Florida Power & Light Company  
St. Lucie Unit 2  
Docket No. 50-389

Subject: Response to NRC Request for Additional Information

**Individual Responses to NRC RAIs for FPL Generic Letter GL 2004-02  
Supplemental Responses, Dated 02/27/2008 and 06/30/2008**

Figure 23-1: Close up of Debris Laden Strainer

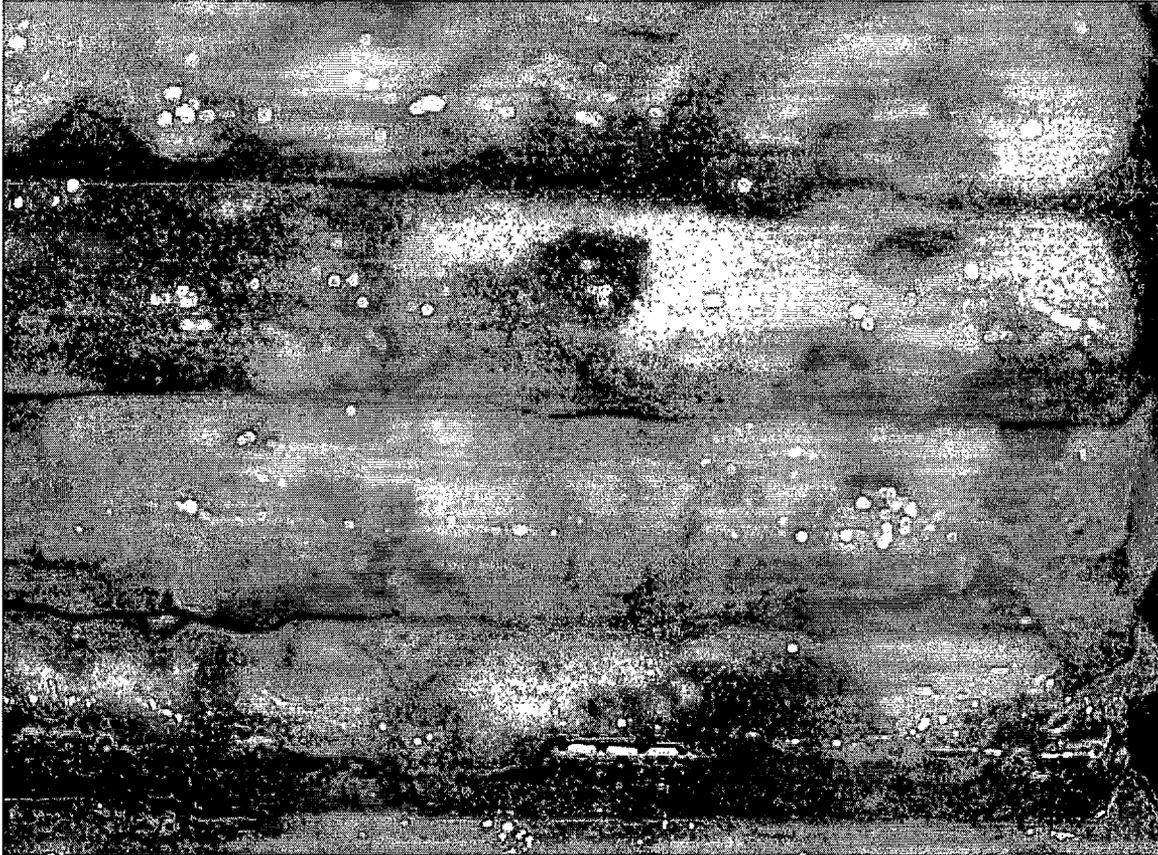
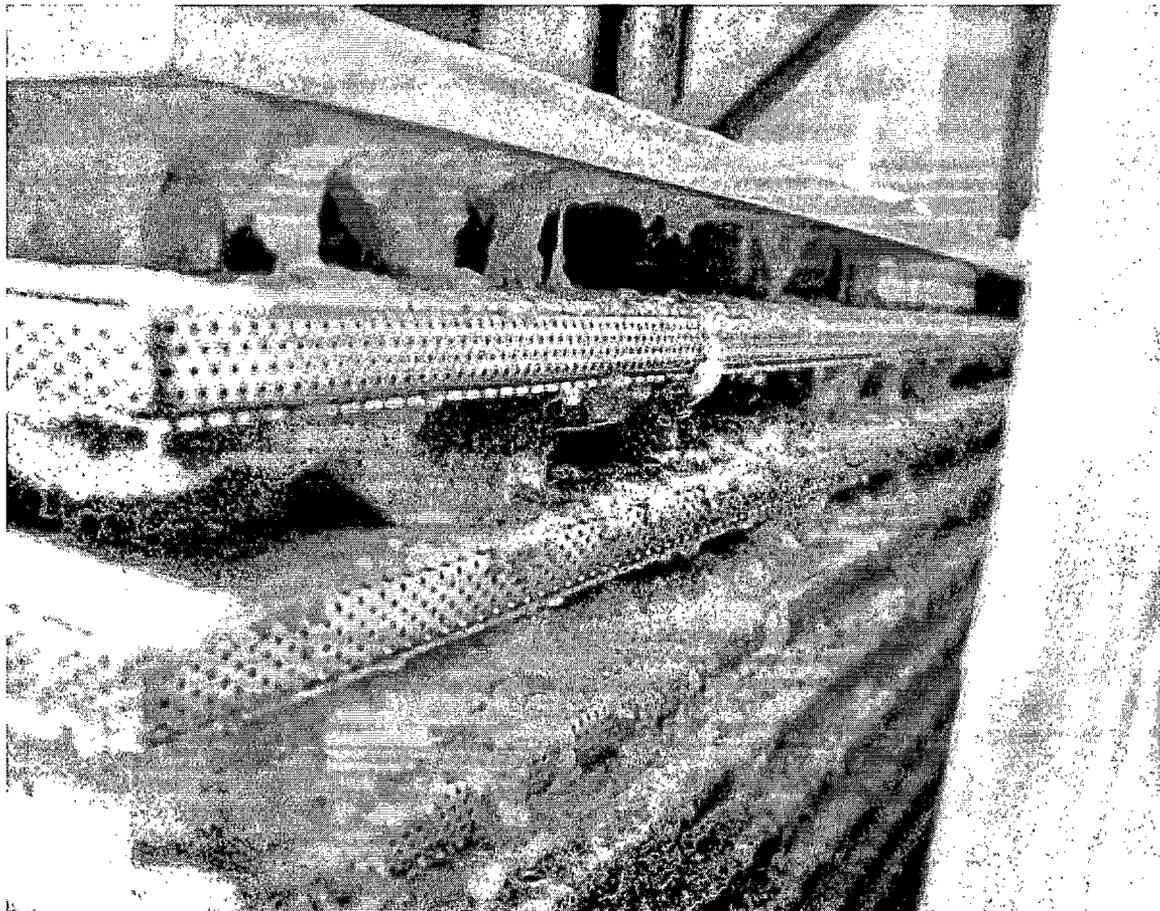
**RAI-23:** Provide the details of both the methodology and results for the thin bed search tests that were conducted. Include the incremental amounts of fibrous debris added along with the number of flume turnovers between additions.

**RAI-23 RESPONSE:** For St. Lucie Unit 2 thin bed testing was not performed based on the performance of the design basis test. It was concluded after the design basis debris loaded strainer test that open strainer surface was observed. Therefore, a thin bed had not formed when subjected to the full debris load. Figure 23-1 below documents the strainer surface area observed after the design basis test was complete.

Fiber bypass testing was conducted in accordance with the St. Lucie Unit 2 Strainer Test Plan. Fiber bypass testing placed the same amount and types of fibrous debris in the flume as the design basis test (reference 3, attachment 1, test 1B and test 2). While this test was not designed to create a 0.125" thin bed it demonstrates the 100% fiber load does not create a thin bed and results in clean strainer area as documented in figure 23-2 below.

Figure 24-1: Head Loss Versus Time For PSL2

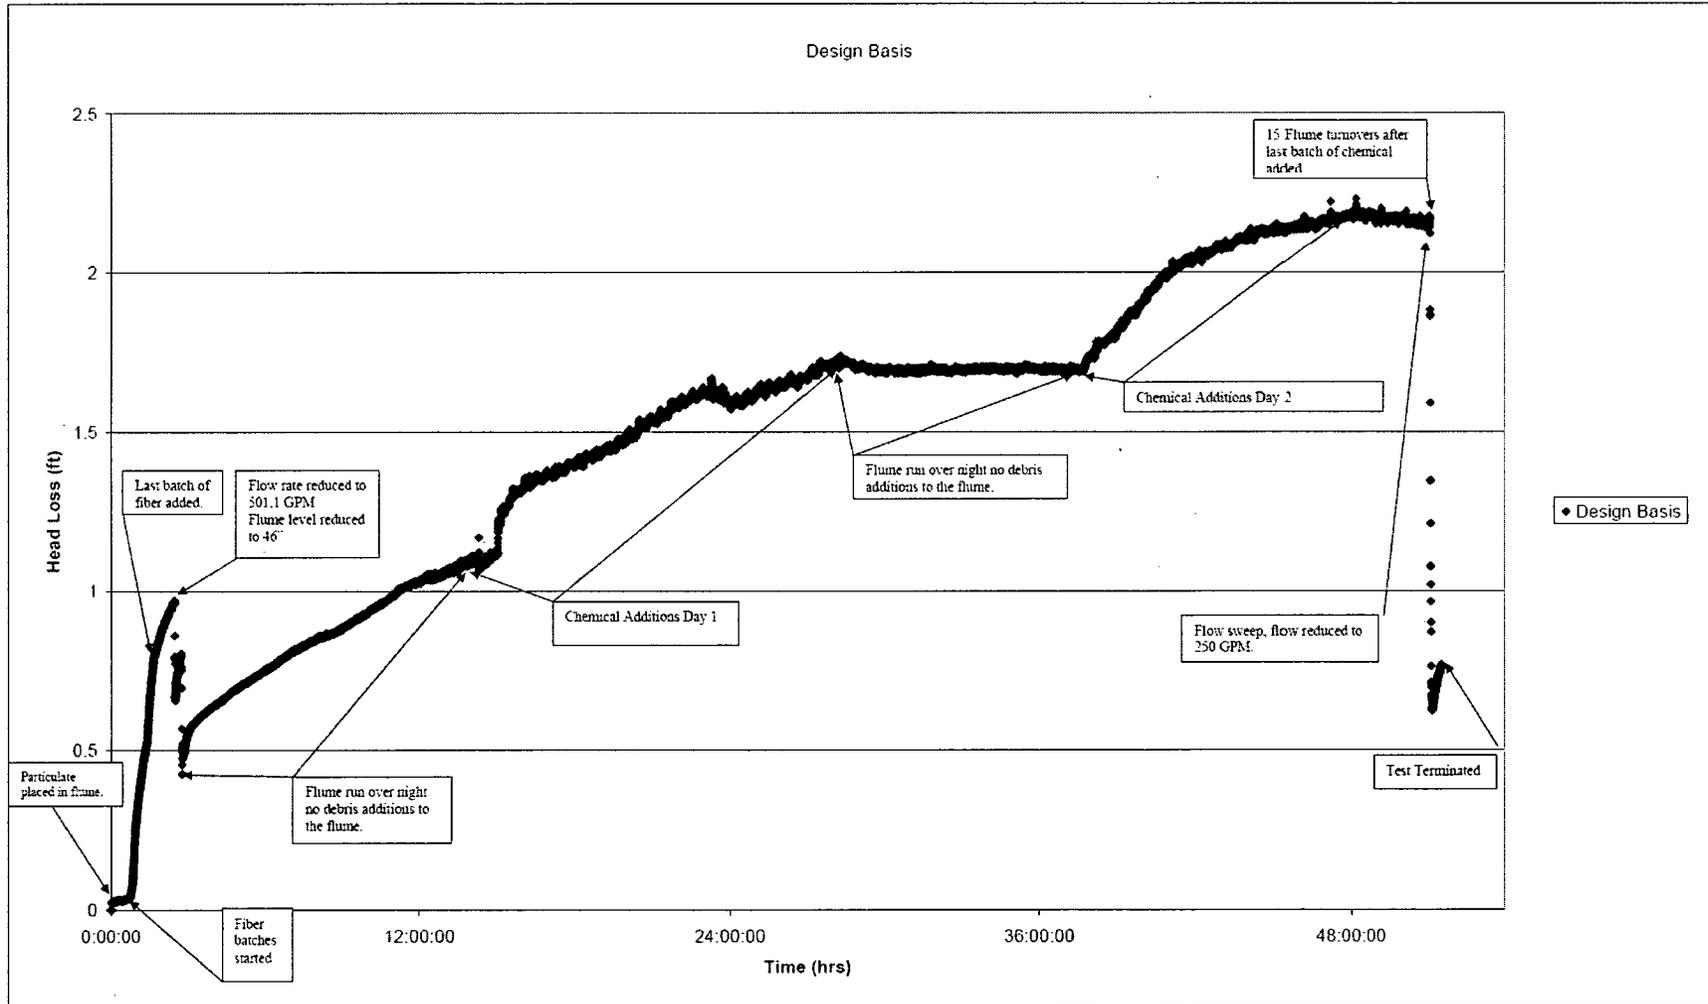
**RAI-24:** Provide a graph of the head loss testing for the duration of the chemical effects test including the non-chemical portions. Include information regarding events that would be expected to affected strainer debris bed head loss such as debris addition, large flow changes, etc.

**RAI-24 RESPONSE:** The head loss curve is presented below as Figure 24-1, the curve was developed with the raw data collected while testing and documented in the test plan.

Figure 35a-1: Head Loss Versus Time for PSL2

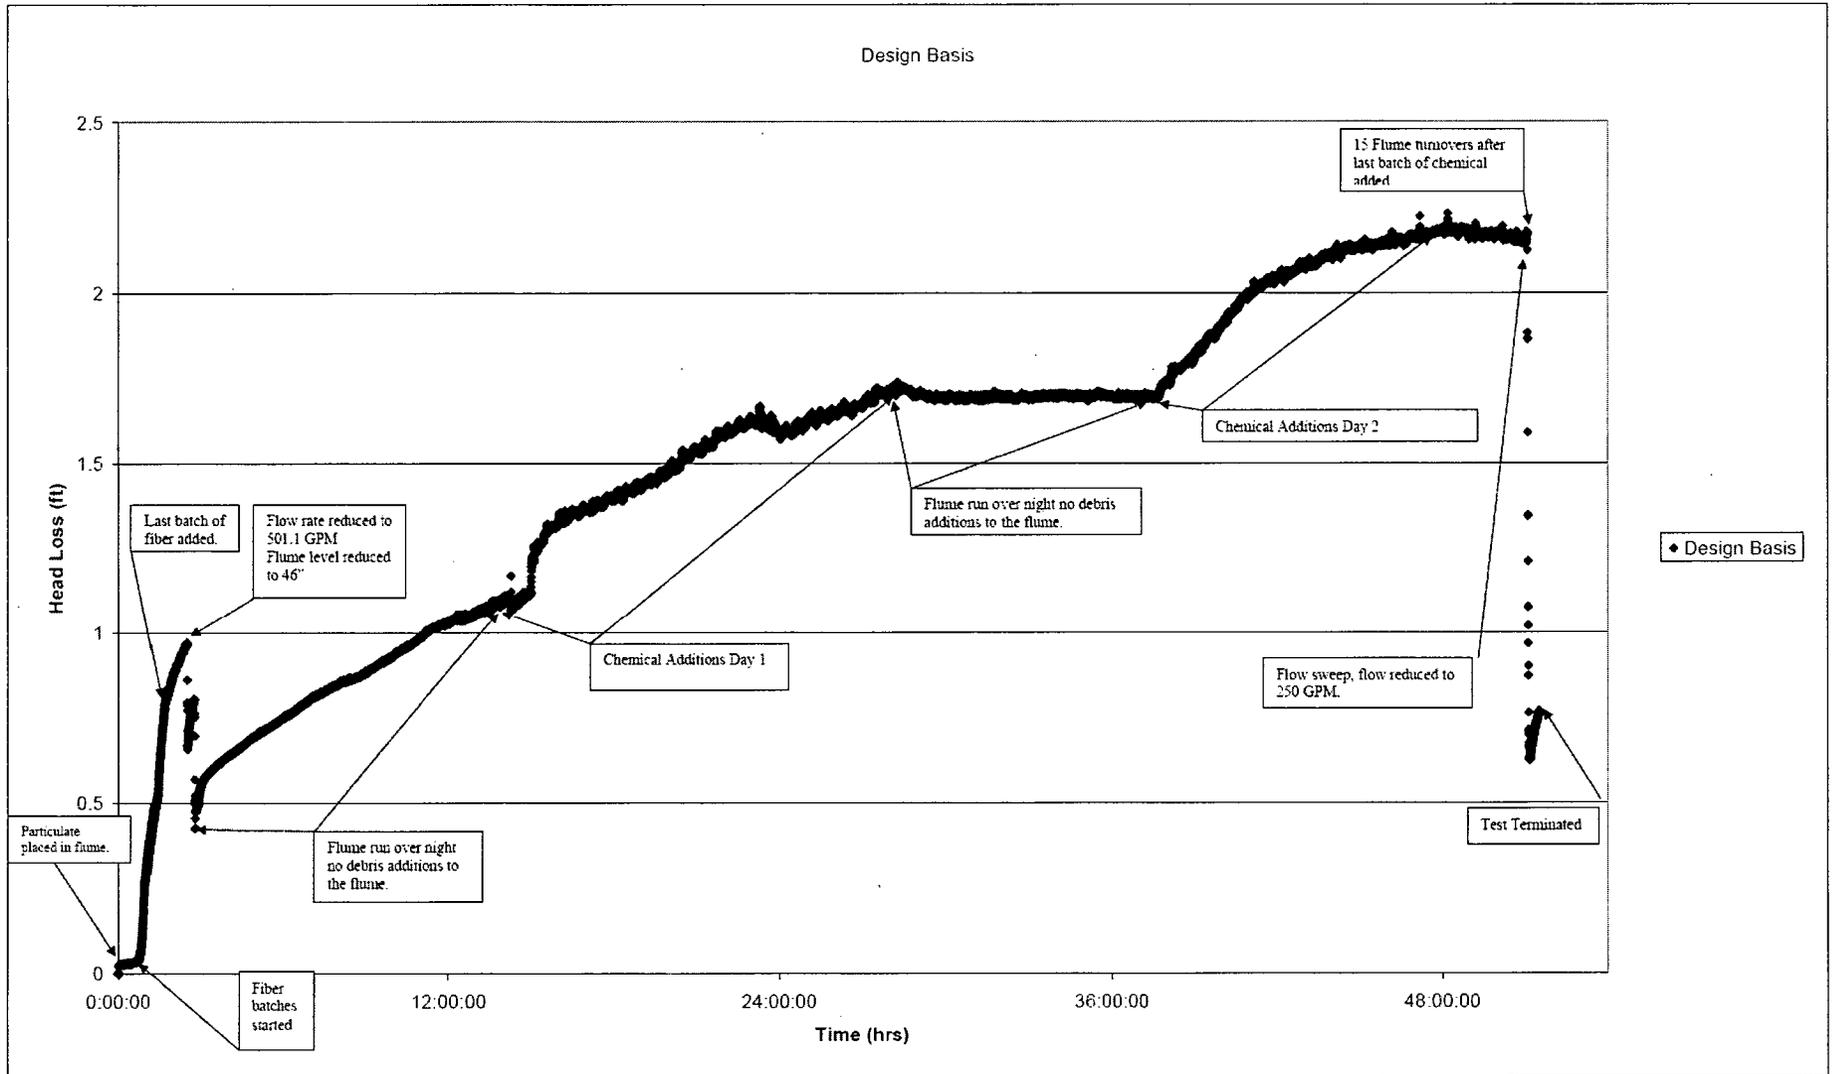
A Plot of the pressure drop as a function of time that also shows when debris and chemical precipitates were added to the test flume.

**RAI-35a RESPONSE:** A plot of head loss versus time was not completed while developing the St. Lucie Unit 2 Strainer Test. The graph presented below was developed for this RAI based on the raw data contained in the St. Lucie Unit 2 Strainer Test Plan. See Figure 35a-1, head loss versus time (test hours) plot below.
